Item ID: D350-591-214

Item Name: Heli-Access-Step™ RH - High Gear, Short Step, Aerazur Float Compatible

DART SERVICE INSTRUCTION

TO AMEND INSTALLATION INSTRUCTIONS D350-591 REV. G AND
INSTRUCTIONS FOR CONTINUED AIRWORTHINESS ICA-D350-591 REV. 3
REF TCCA STC: SH92-6
REF FAA STC: SH967NE

FIGURE 1: CLAMP DETAIL
OPTIONAL CLAMP CONFIGURATION

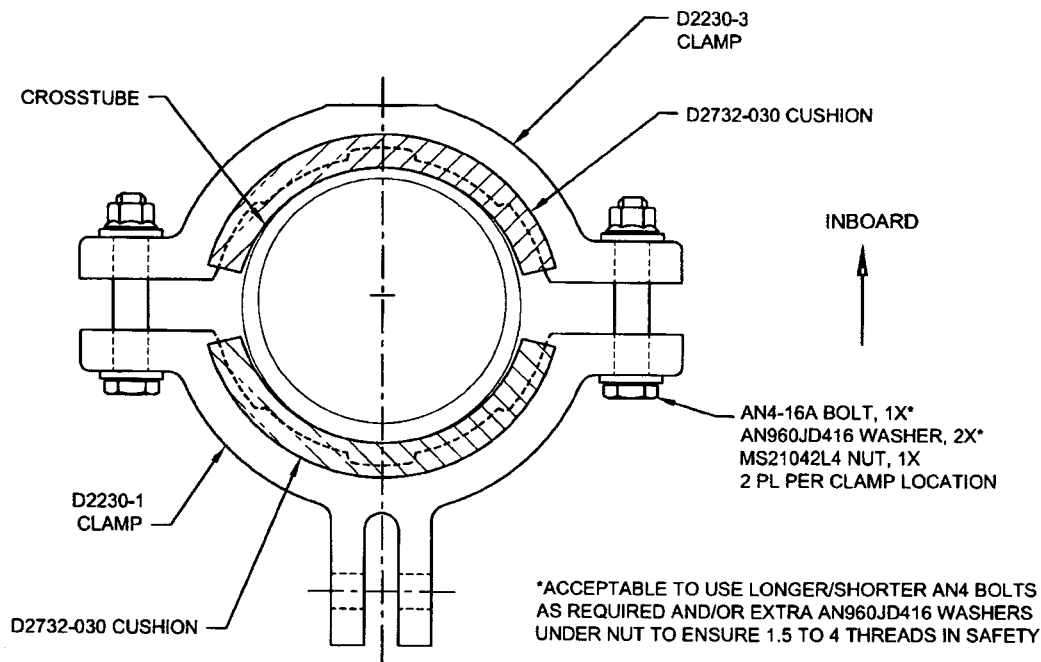
For D350-591-213/-214/-215/-216 steps, customers have the option of installing D2732-030 cushion under the clamps to accommodate varying crosstube diameters and to improve fit, as indicated in Installation Instructions D350-591. This Service Instruction adds longer AN4-16A bolts to the parts list to allow installation of these cushions. See Figure 1 on sheet 2 of this service instruction for reference. Installation of the D2856-400-720 Abrasion Strips per Installation Instructions D350-591 is not required when the cushions are installed.

For D350-591-213/-214/-215/-216 steps at CHG 003, the parts list of D350-591 Rev. G and ICA-D350-591 Rev. 2 is amended as follows:

Qty -213	Qty -214	Qty -215	Qty -216	Part Number	Description
X				D350-591-213	<i>Heli-Access-Step</i> ™, Short Step – High Skid, LH
	X			D350-591-214	<i>Heli-Access-Step</i> ™, Short Step – High Skid, RH
		X		D350-591-215	<i>Heli-Access-Step</i> ™, Short Step – Low Skid, LH
			X	D350-591-216	<i>Heli-Access-Step</i> ™, Short Step – Low Skid, RH
4	4	4	4	AN4-16A	BOLT

VIEW G-G: FWD CROSSTUBE
LH INSTALLATION SHOWN (RH OPPOSITE)
SCALE 6X

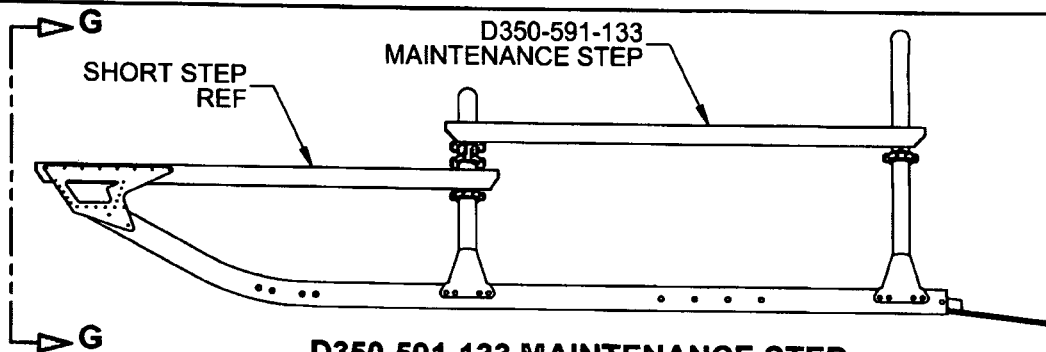
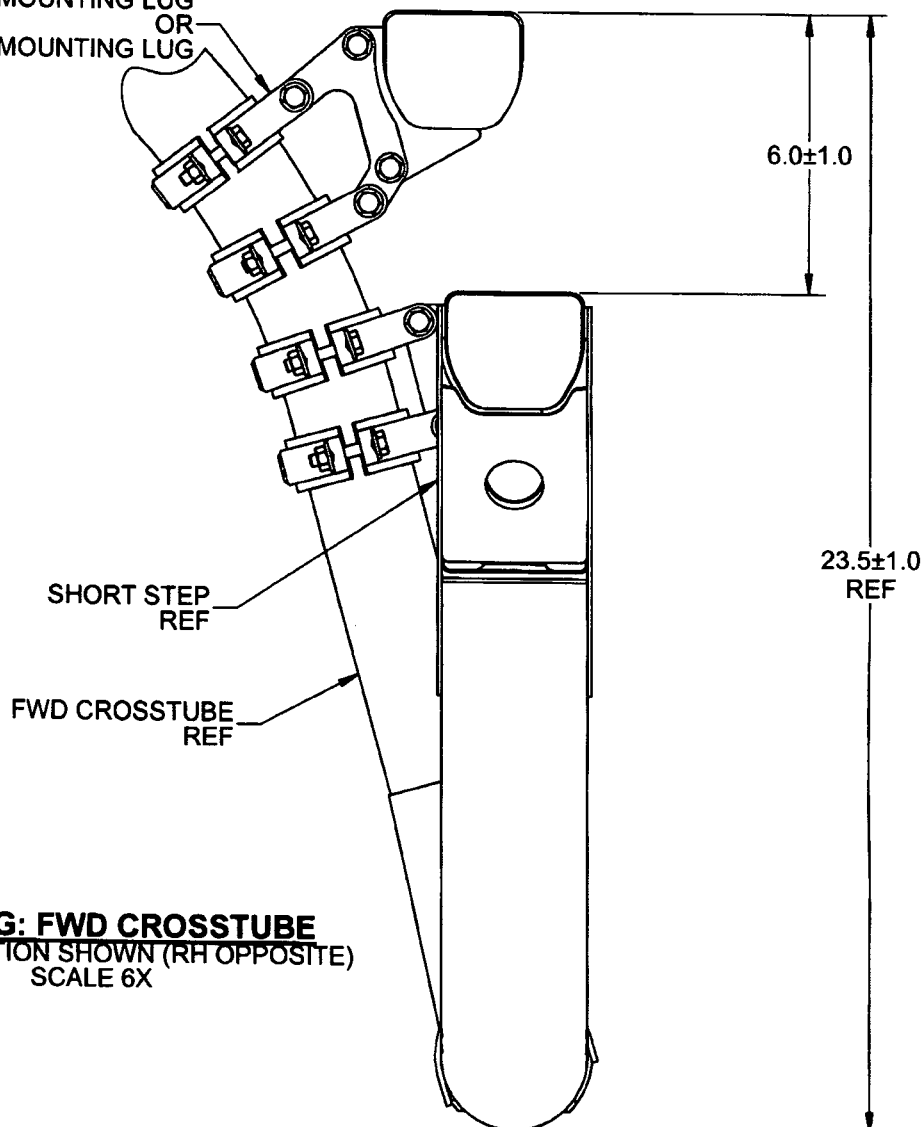
It has come to DART's attention that it may be difficult to fasten the D350-591-133 Aft Maintenance Step and D350-591-213/-214 Heli-Access-Step Installations to the forward crosstube due to variations between crosstubes. For this reason, DART is adding the D3338-1 Mounting Lug to the D350-591-133 Aft Maintenance Step and D350-591-213/-214 Heli-Access-Step Kits at CHG 004 and later.

- 2.1 It is acceptable to install the D3338-1 Mounting Lug in lieu of the D2230-1 Mounting Lug as required to reduce the gap between step and the forward crosstube in accordance with the figures of this service instruction.
- 2.2 The height to set up the D350-591-133 Maintenance Step has been revised from 7.0in to 6.0in $\pm$ 1.0in to provide more flexibility. See sheet 2 of this service instruction.
- 2.3 In all other respects, install the D350-591-133 Aft Maintenance Step and D350-591-213/-214 Heli-Access-Steps in accordance with Section 3.1 of Installation Instructions D350-591 or Section 32.1 of Instructions for Continued Airworthiness ICA-D350-591.

D2230-1 MOUNTING LUG
OR
D3338-1 MOUNTING LUG
